7.2 Reactor Protection (Trip) System (RPS)—Instrumentation and Controls

The information in this section of the reference ABWR DCD, including all subsections, tables and figures, is incorporated by reference with the following departures and supplements.

STD DEP T1 2.3-1 (Table 7.2-1, 7.2-2, Figures 7.2-2, 7.2-6, 7.2-9, 7.2-10)

STD DEP T1 3.4-1 (Figures 7.2-2, 7.2-9, 7.2-10)

Figure 7.2-2 Reactor Protection System Equipment Arrangement (From Sensors Through Trip Actuators)

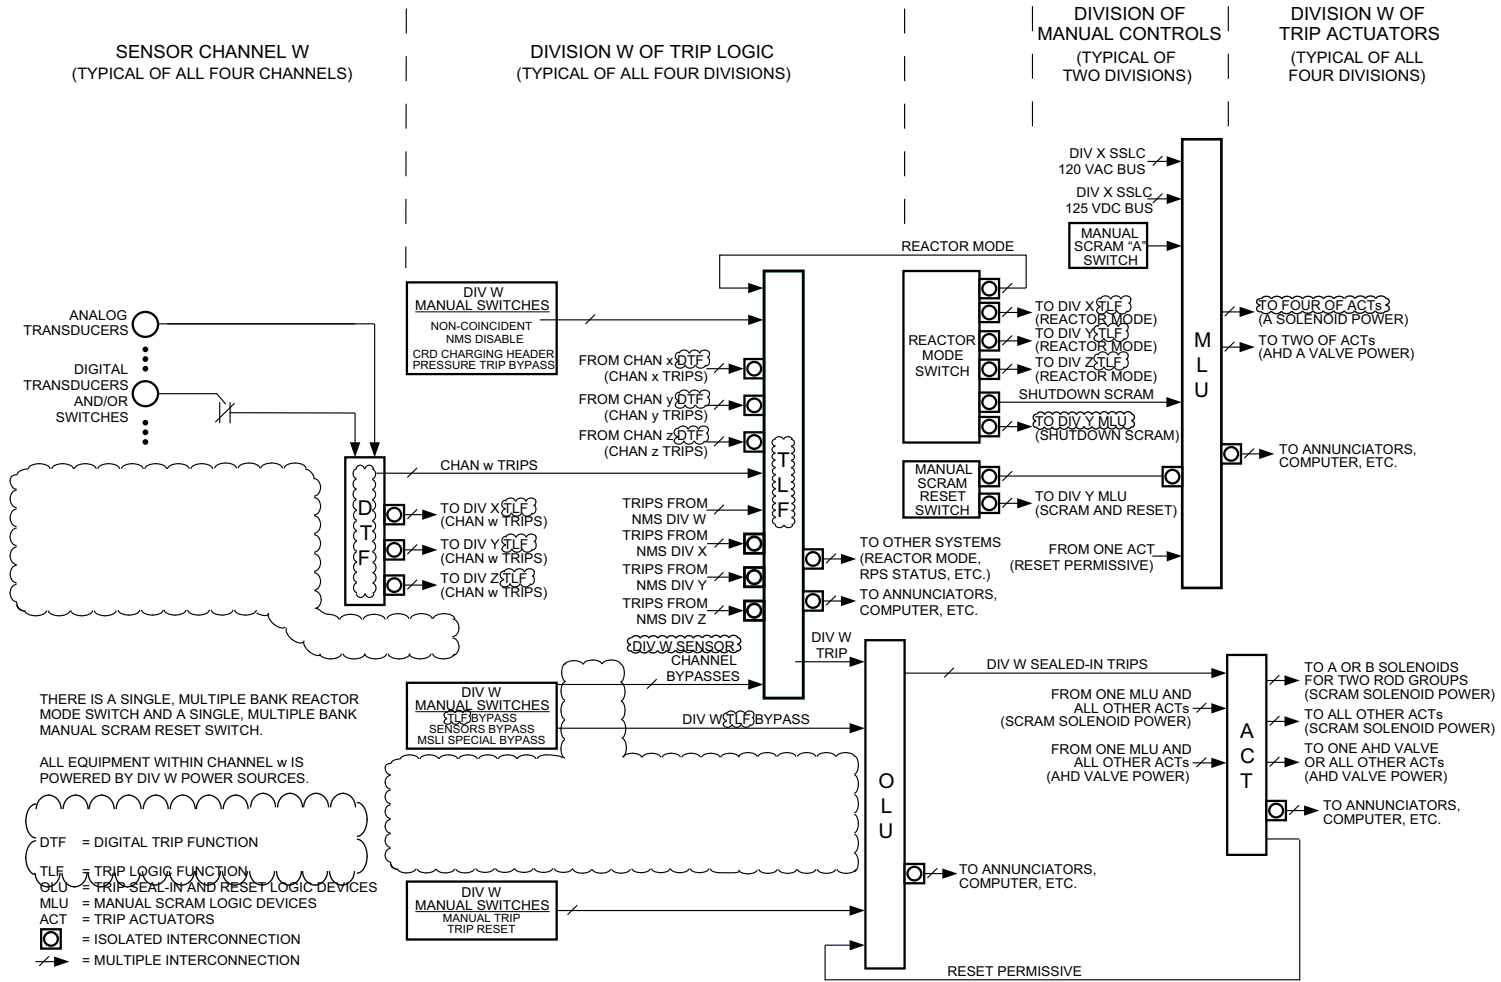
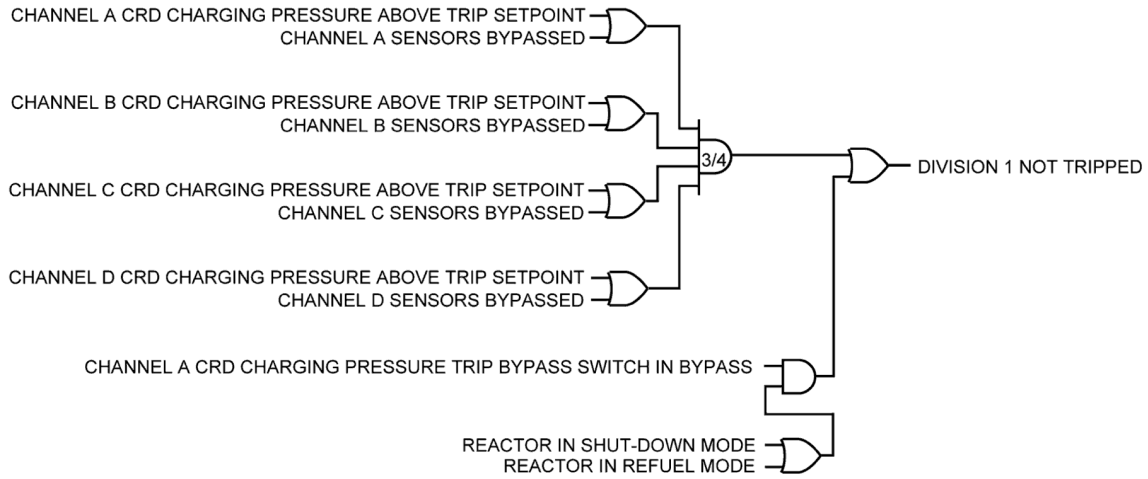
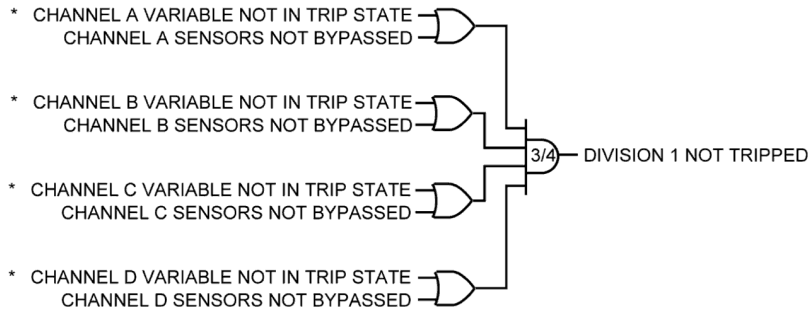
The RPS equipment is divided into four redundant divisions of sensor (instrument) channels, trip logics and trip actuators, and two divisions of manual scram controls and scram logic circuitry. The sensor channels, divisions of trip logics, divisions of trip actuators and associated portions of the divisions of scram logic circuitry together constitute the RPS scram and air header dump (backup scram) automatic initiation logic. The divisions of manual scram controls and associated portions of the divisions of scram logic circuitry together constitute the RPS scram and air header dump manual initiation logic. The automatic and manual scram initiation logics are independent of each other. RPS equipment arrangement is shown in Figure 7.2-2.

Equipment within a sensor channel includes primarily sensors (transducers or switches), ~~multiplexers and digital trip modules (DTMs)~~ trip functions (DTFs). The sensors within each channel monitor plant variables (Subsection 7.2.1.1.4.2) and send either analog or discrete output to remote multiplexer units (RMUs) within the associated division of Essential Multiplexing System (EMS) the DTF. ~~Each division of the EMS performs analog to digital conversion on analog signals and sends the digital or digitized analog output values of all monitored variables to the DTM within the associated RPS sensor channel.~~ The DTF in each sensor channel compares individual monitored variable values with trip setpoint values and for each variable sends a separate, discrete (trip/no trip) output signal to all four divisions of trip logics.
